AUGUST 2022 MINOR NON MATERIAL AMENDMENTS TO MCC PLANNING PERMISSION (REF. 132391/FH/2021)

Scheme
Loft Conversion Works
466 Parrs Wood Road
Didsbury
Manchester M20 5QQ
Client

Mr & Mrs Tennant
Title
Proposed Floor & Roof
Plans

Scale 1:50 Date 2.12.21 Drawn MM
Job No P221 Dwg No 15 Rev B

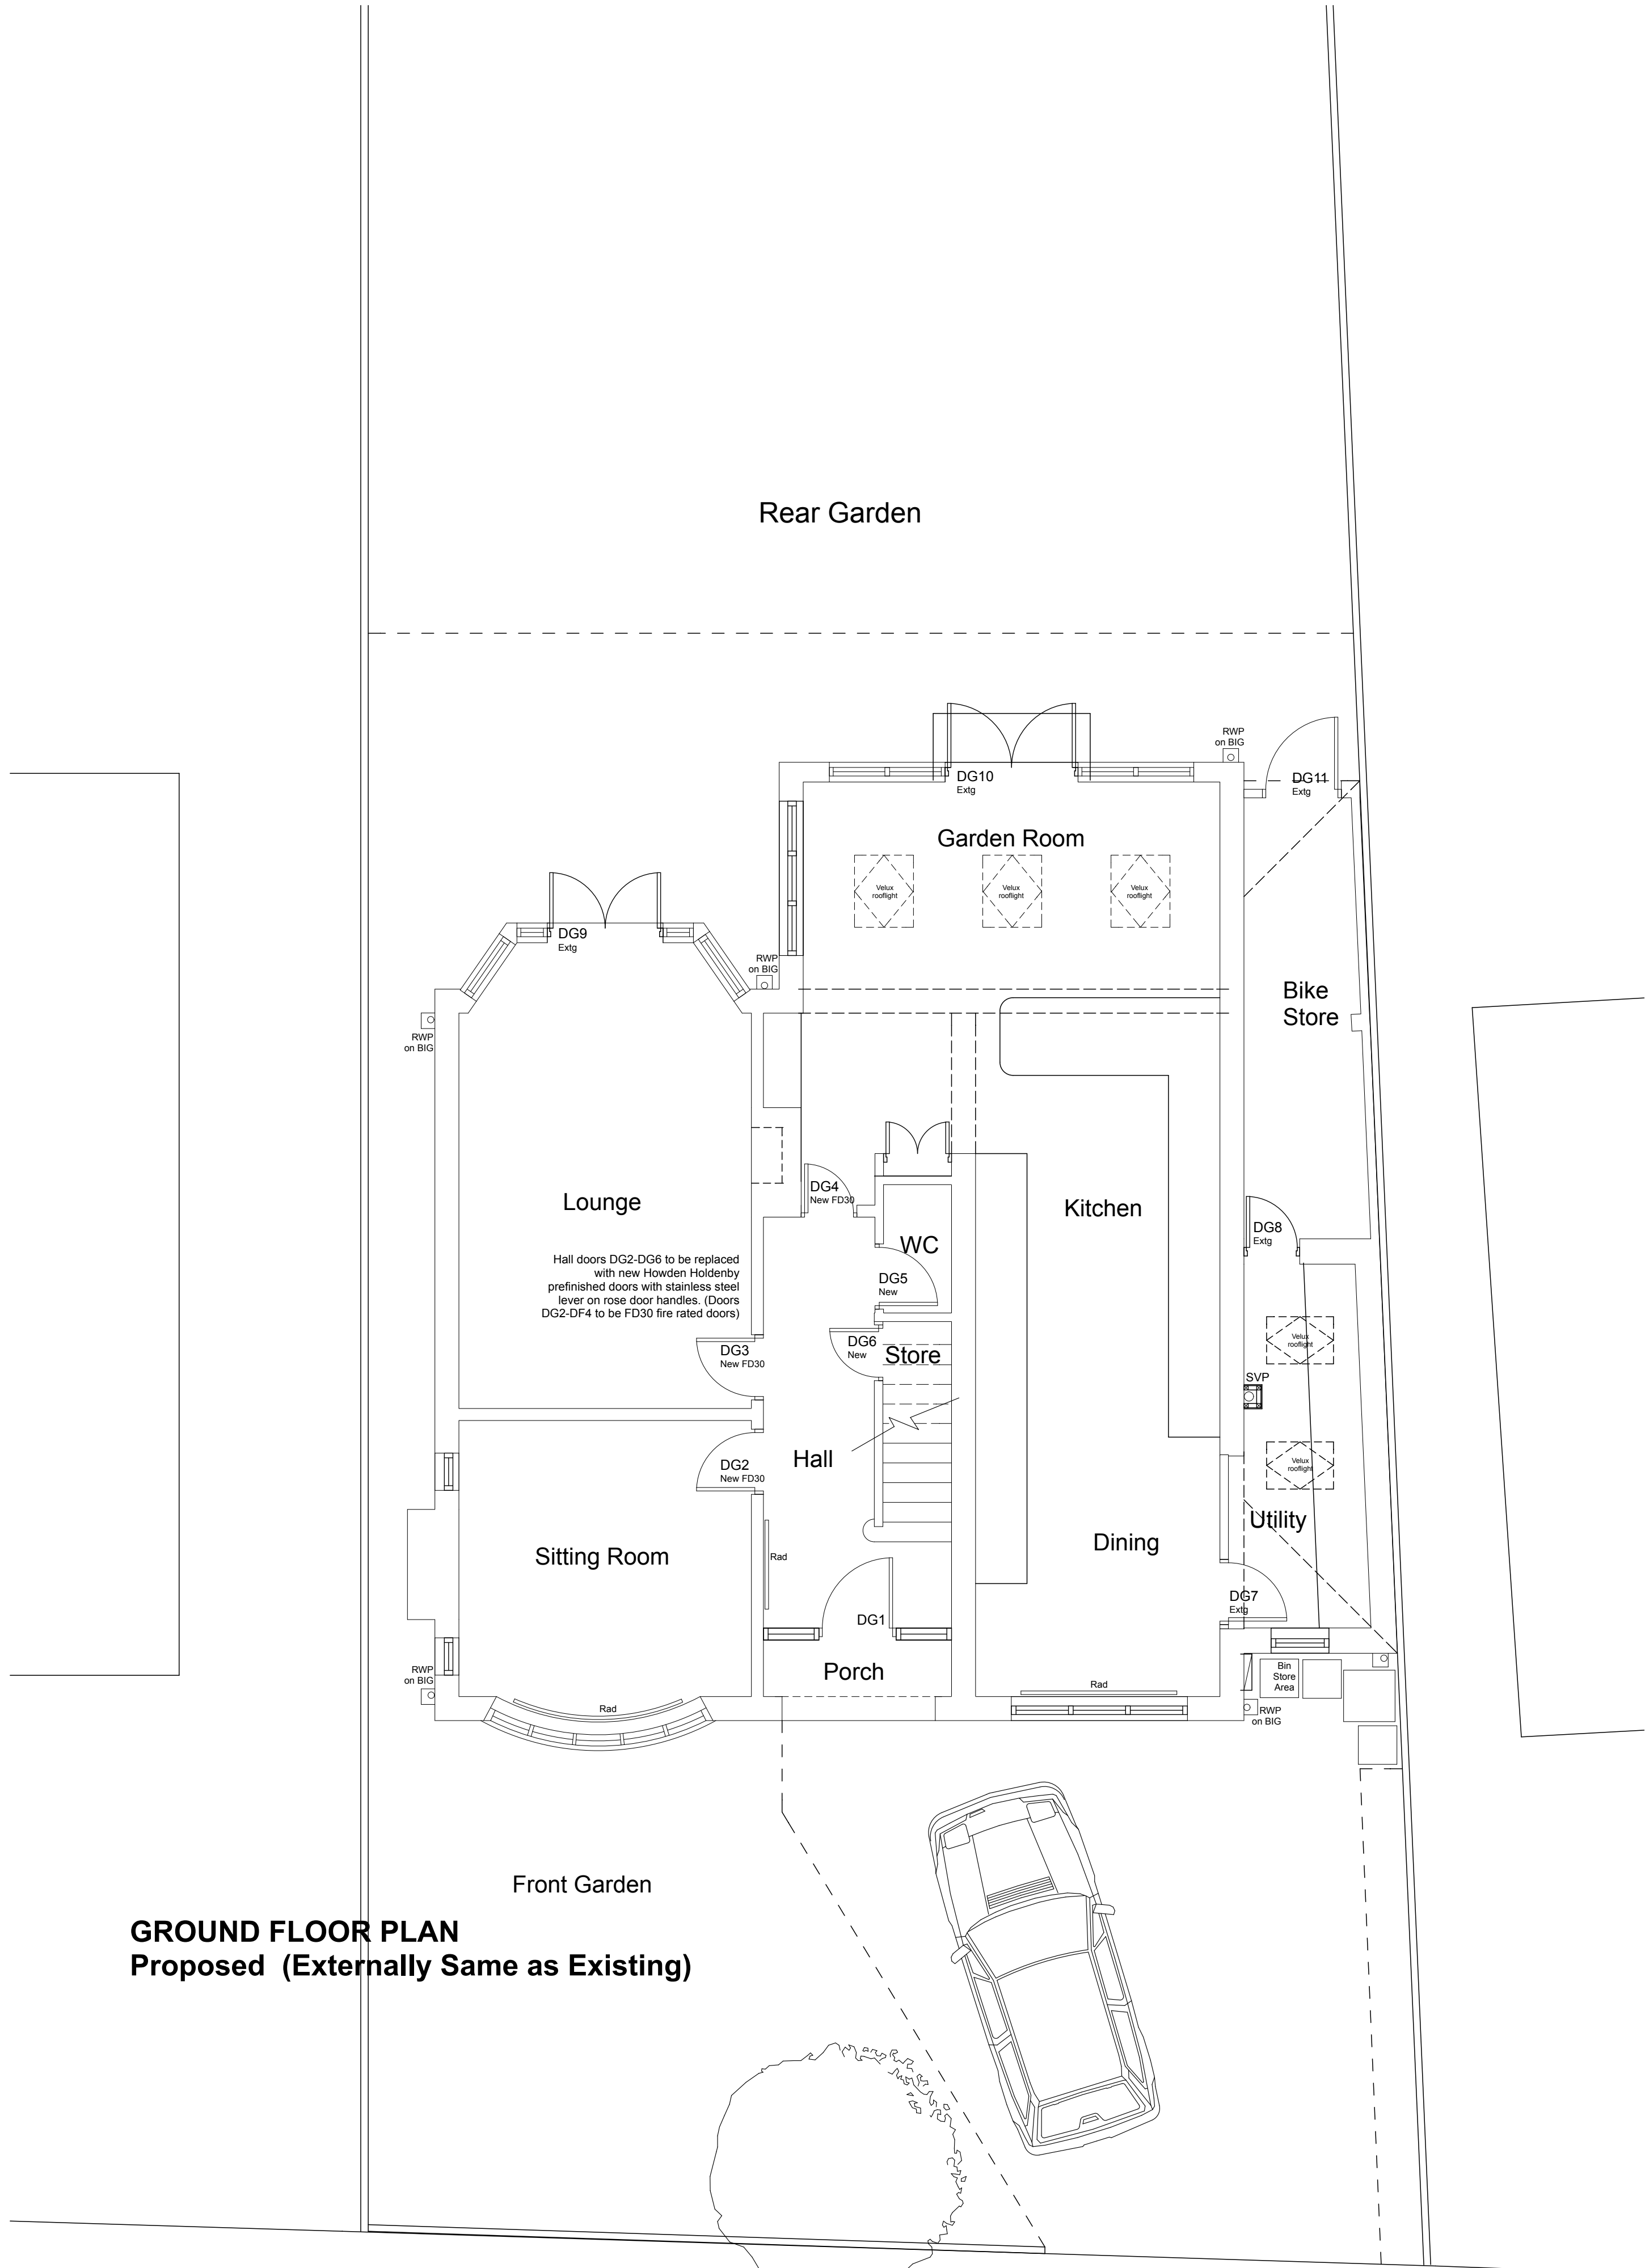
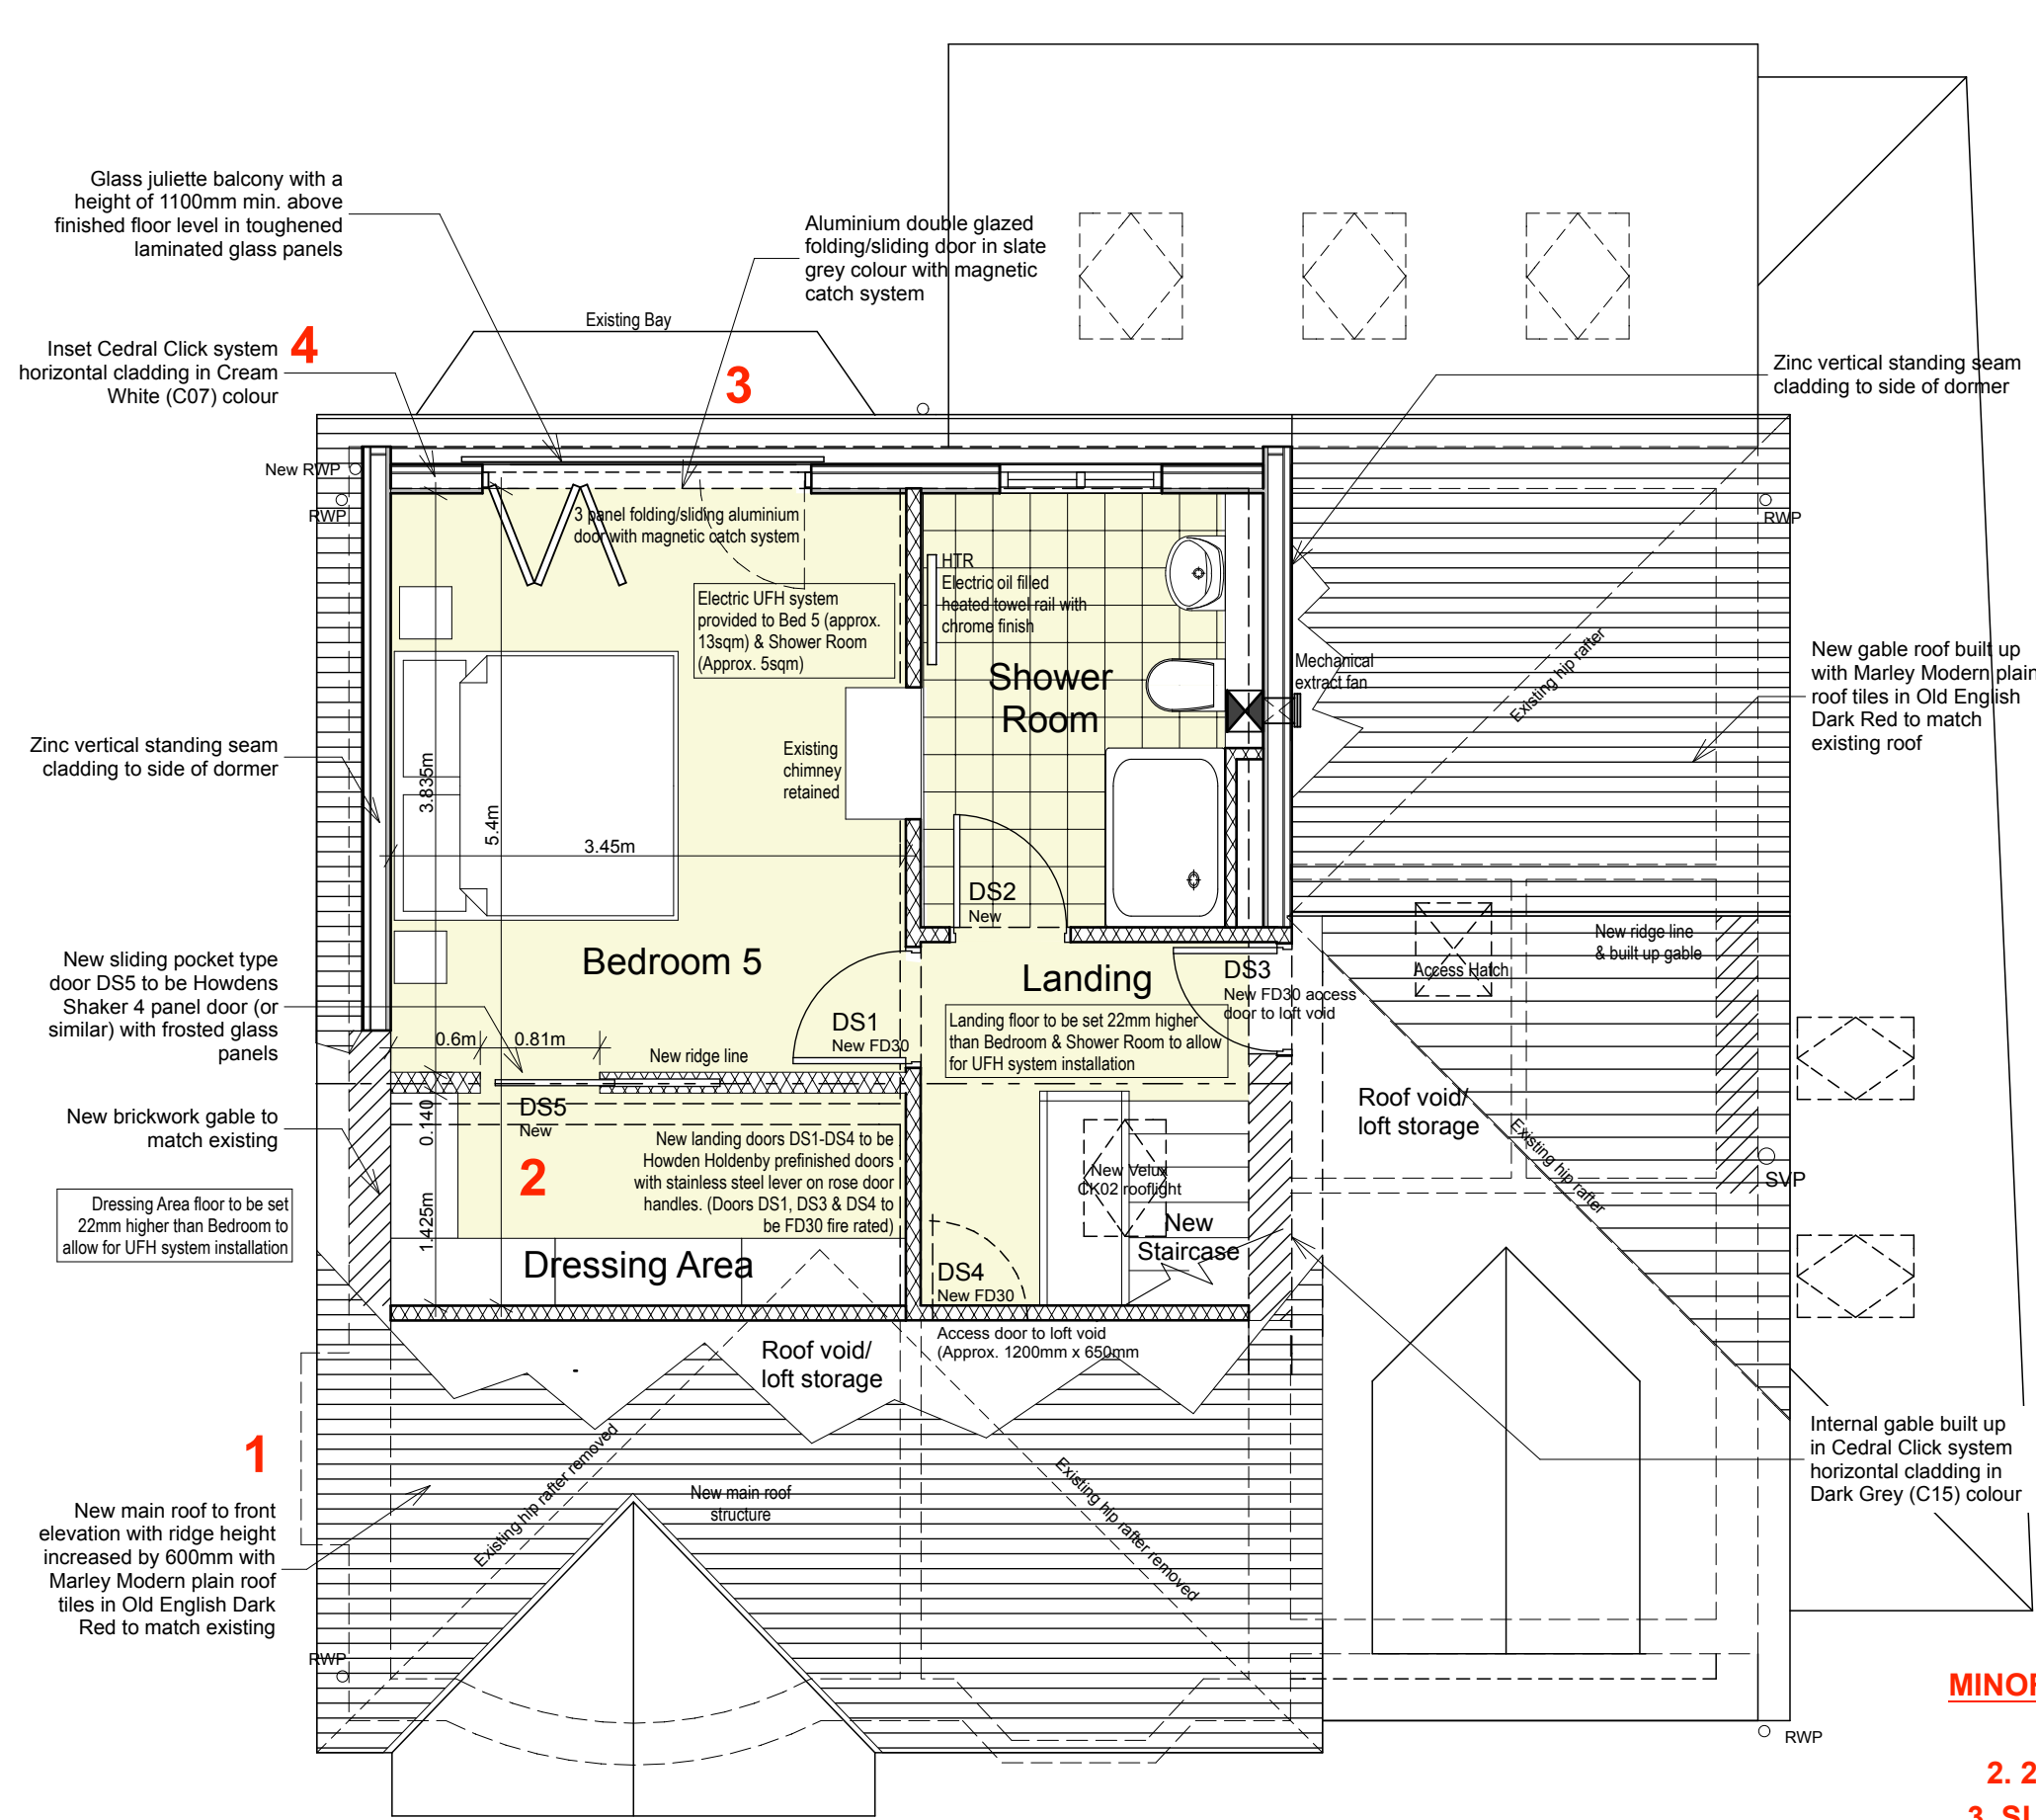
- MINOR ELEVATIONAL NON MATERIAL AMENDMENTS (AUGUST 2022)**
1. SOLAR PANELS OMITTED TO FRONT ELEVATION ROOF
 2. 2NO. VELUX WINDOWS OMITTED TO FRONT ELEVATION ROOF
 3. SLIDING FOLDING DOORS PROVIDED TO SECOND FLOOR REAR ELEVATION IN LIEU OF GLAZED SCREEN/DOOR
 4. CEDRAL CLADDING ON DORMER LOFT REAR ELEVATION AMENDED FROM DARK OAK TO CREAM WHITE (C07) COLOUR
 5. EXISTING CHIMNEY BUILT UP IN BLUE ENGINEERING BRICKWORK 0.75m ABOVE NEW DORMER LOFT ROOF

B. NMA Inner gable cladding changed back to original facing brickwork to match existing 19.8.22
A. NMA Planning Amendments + Internal Notes 19.7.22
REVISIONS
